Memorandum

Re: Appeal of JenkinsGavin Design & Development, Inc.,
Agent for Aguafina Development LLC
from the September 12, 2013 Decision of the Planning Commission
in Case #2013-58 Denying its Application for Preliminary Subdivision Plat Approval
and a Variance from the City's Access and Traffic Calming Standards
Case No. 2013-93

Date: December 27, 2013 for the January 8, 2014 Meeting of the Governing Body

Aguafina

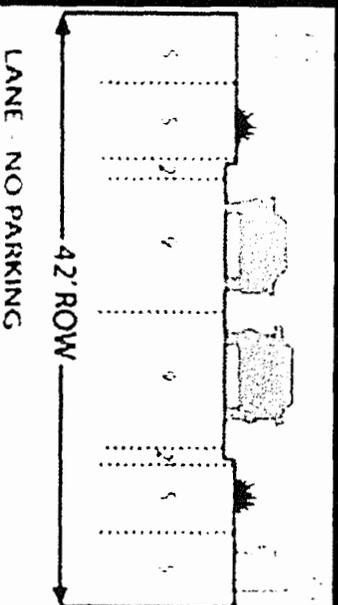
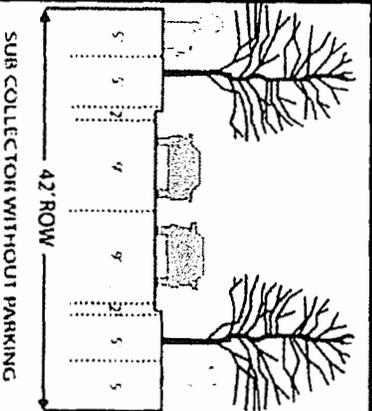
- Traffic Engineer & Fire state site should have two points access
- Subcollector/Lane as minimum street standard
- Agua Fria Road access point for emergency access only
